FINAL PLAT

ELIZABETH'S ADDITION

Re: S/D 91-12 (Final Plat) Elizabeth's Addition

S/D 91-12 - ELIZABETH'S ADDITION

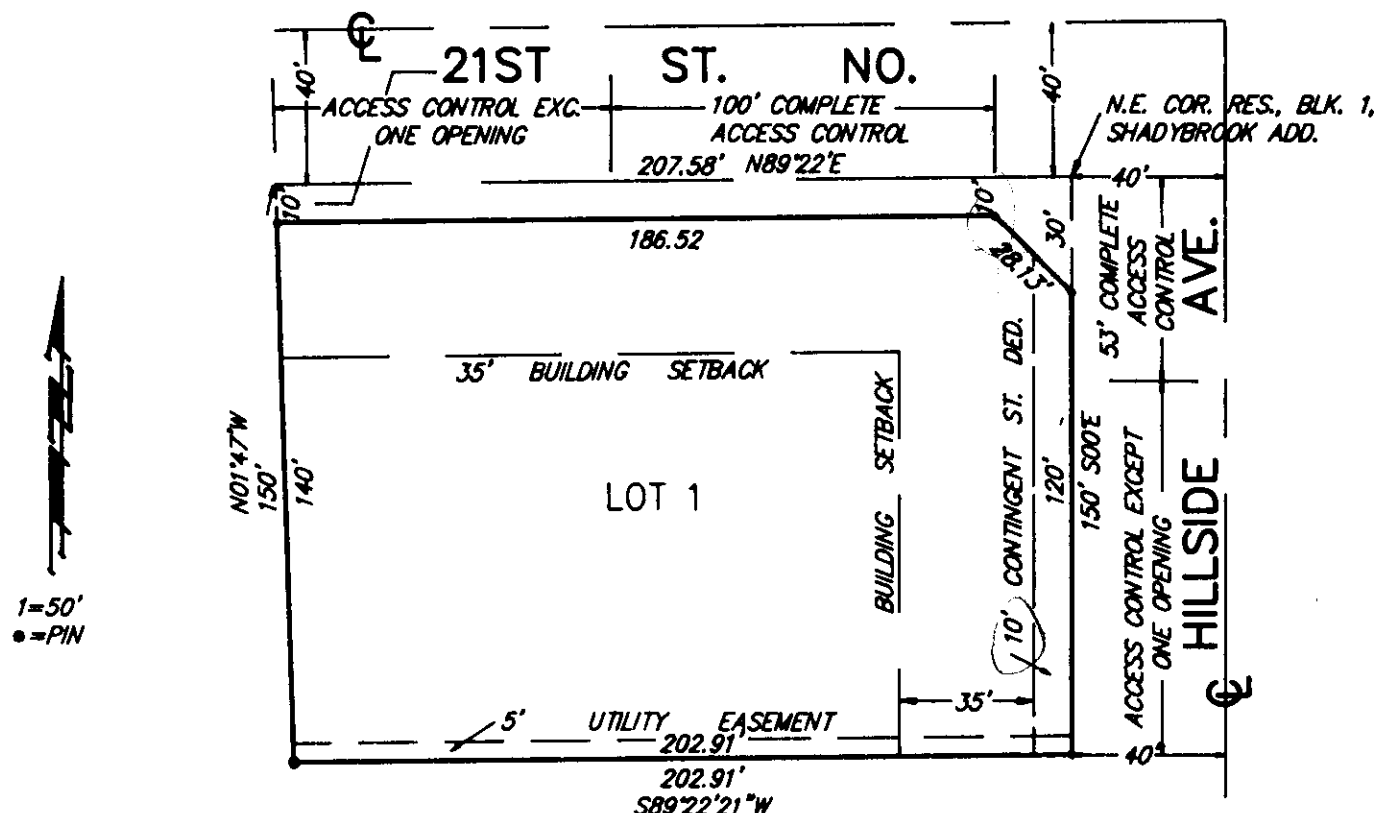
building setbacks do not preclude the property owner from maintaining or remodeling that portion of the building within the setback area. The building cannot, however, be enlarged within the setback and, if the building is removed, any new building construction must observe the platted building setback.

- J. Presently, one of the owners of this site is indicated as J. and Viola Chenn. The final plat tracing shall either include these owner's signatures or a revised title policy will need to be submitted indicating the change in ownership, as now shown on the plat (Julius and Lois Smith).

- N. Perimeter closure computations shall be submitted with the final plat tracing. Section 5-101(c).
- O. Recording of the plat within 30 days after approval by the City Council.

- A. The applicant shall guarantee the closure of those driveways in excess of the access controls being established for this plat. Specifically, the closure of two drives to 21st Street North, and one drive to Hillside.

- B. The applicant shall submit a guarantee for the provision of a decel lane to serve this site. This guarantee will be held pending determination of whether landscaping improvements along 21st St. North would make such an improvement inappropriate.

- E. Subdivision Regulations state that the right-of-way for intersections of major arterials shall be 75-feet of half for a distance of 250 feet from the intersection, tapering to 50-feet of half. Since this is a developed area, 60-feet of half street right-of-way will be required along both 21st St. North and Hillside as indicated by the original Quiktrip 5th Plat.

- F. Prior to submitting the final plat tracing, the applicant shall also meet with Traffic and City Engineering to determine the amount of right-of-way to provide at the plats northeast corner for the 21st and Hillside intersection.

- G. The access control, as shown, may be inadequate for the amount of right-of-way required. The final plat tracing shall indicate 40-feet of complete access control allowing for the additional right-of-way along Hillside from the intersection of the arterial streets.

- H. On the final plat tracing, a 10-foot utility easement shall be indicated along the site's south line. Utilities and sanitary sewer are located in what is presently only a 15-foot easement, 5-feet being on this site and 10-feet on the adjoining property. A 20-foot easement is required.

- I. The final plat shall indicate the platting of the 35-foot building setback from 21st Street North and Hillside through the existing buildings which encroach into the setback areas. Central Inspection has advised that the platting of these
